OCD Version #1

OCD Version 2

OCD Version 3

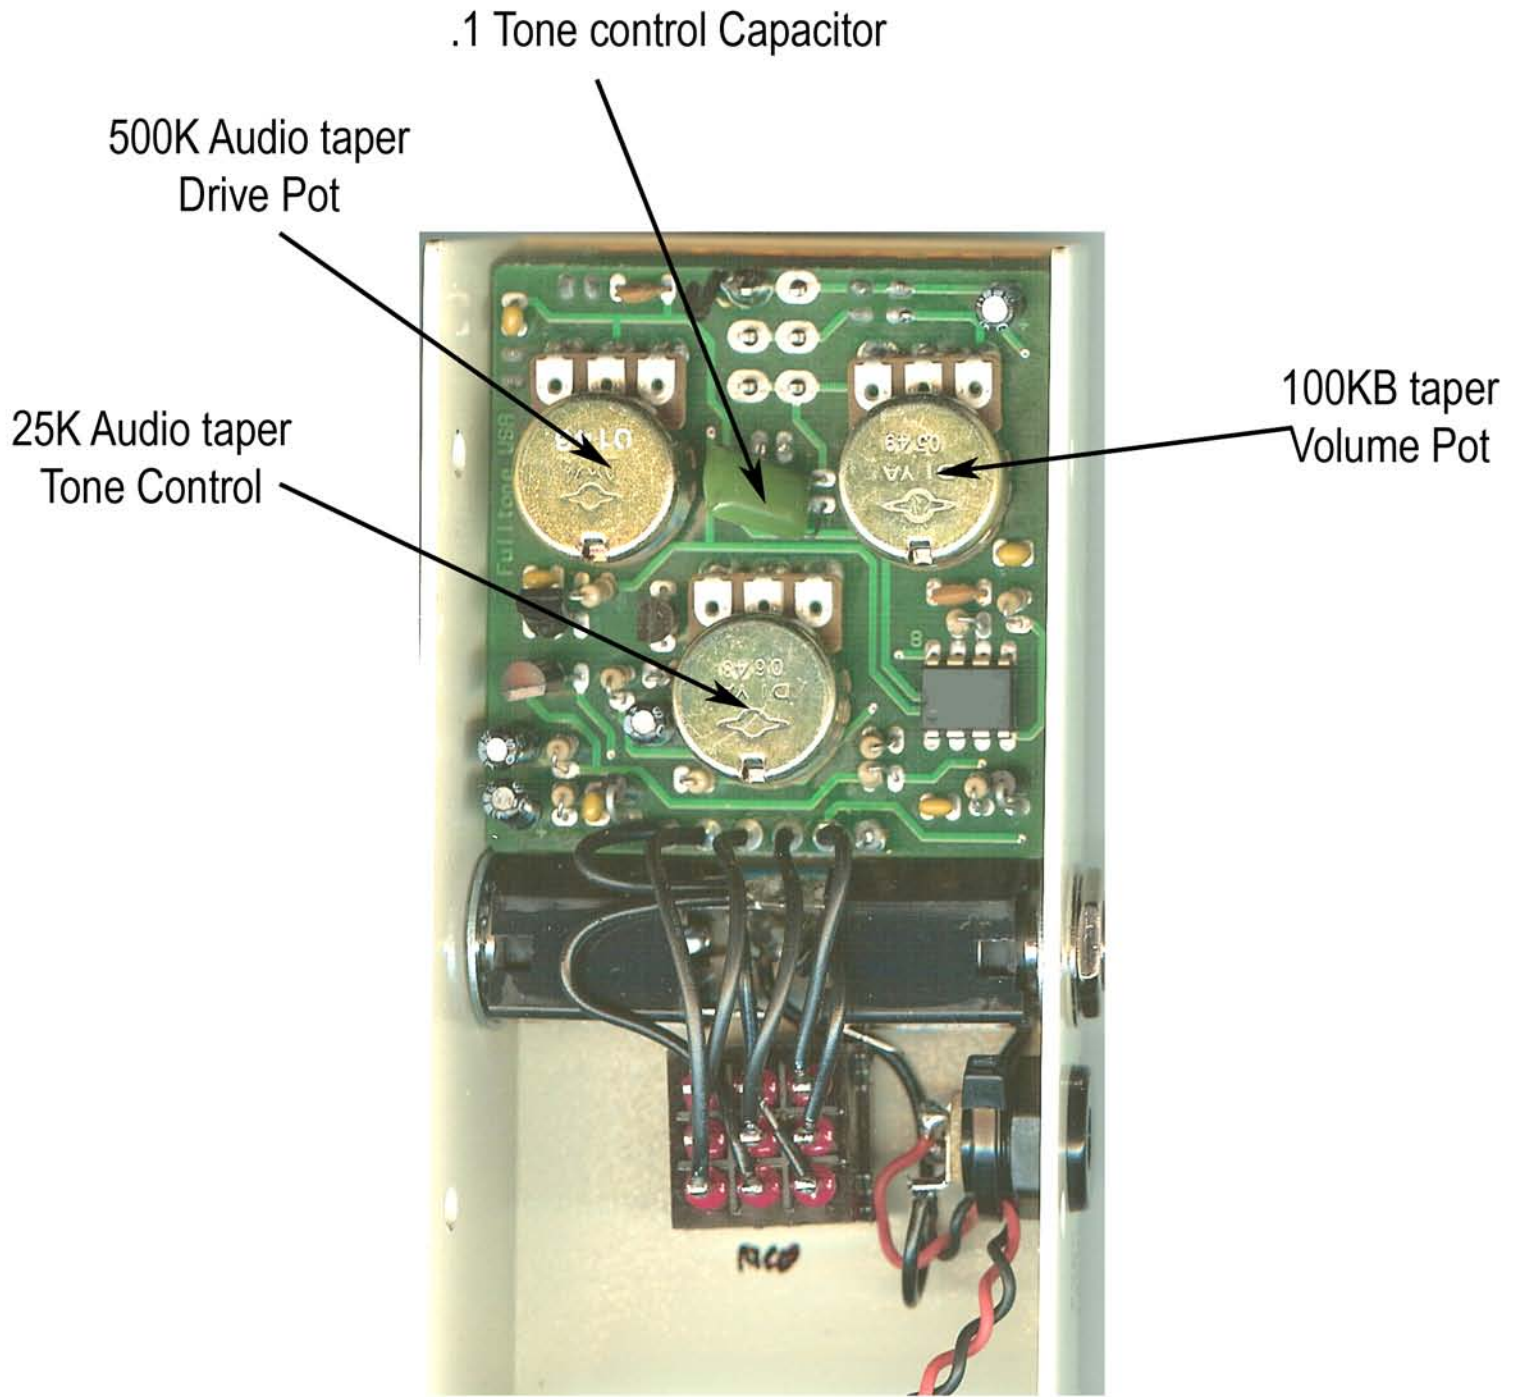
Due to large amounts of epoxy covering the PCB,
mods are difficult or impossible to do on Version 1 OCD's.

Notes: Lots of Bass, lots of treble, a little sizzly on the hi-end

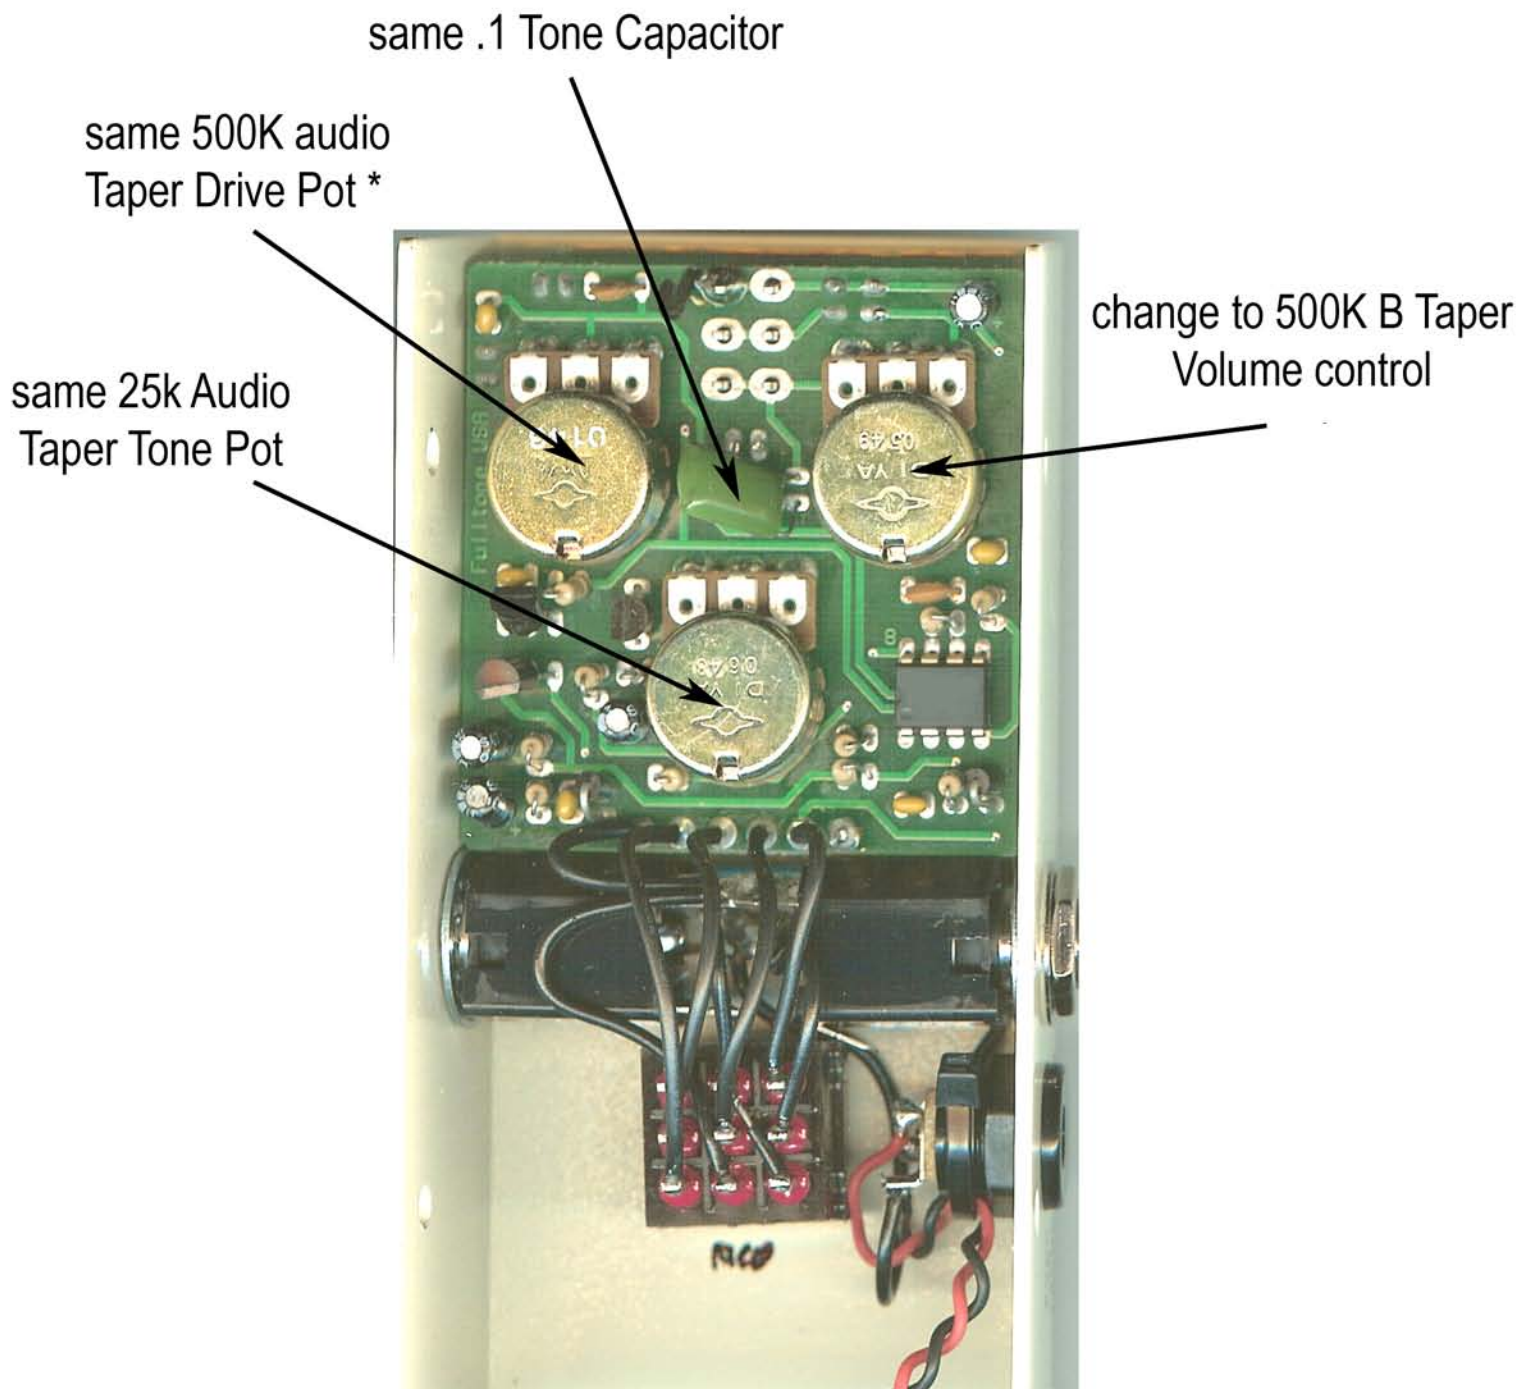
Notes: Less Bass, more Mids than V1, slightly smoother highs

* @ serial#9127 to present have 1 Meg Audio taper Drive Pot for more Distortion

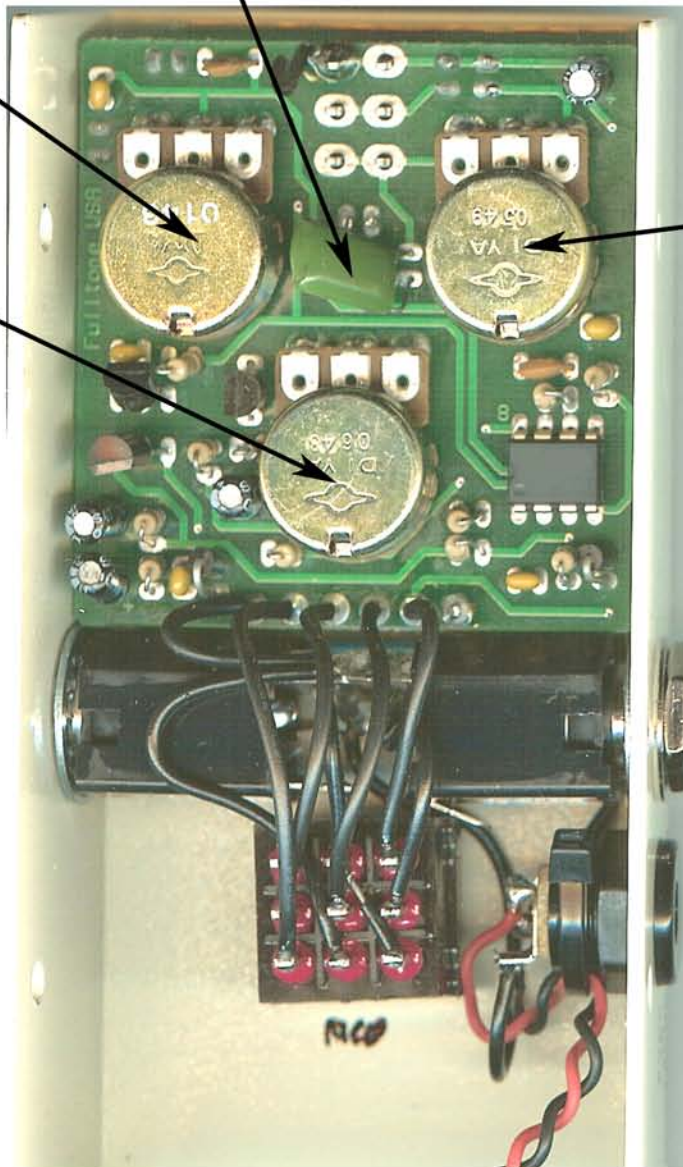
change Tone Control Capacitor
to .047 Mylar, 25 volt or higher

change Drive Pot to
1 Meg audio Taper

change Tone pot to
10K B taper

same 500K B Taper
Volume Pot

Notes: Stronger Mids, more sustain, "better" Tone control.
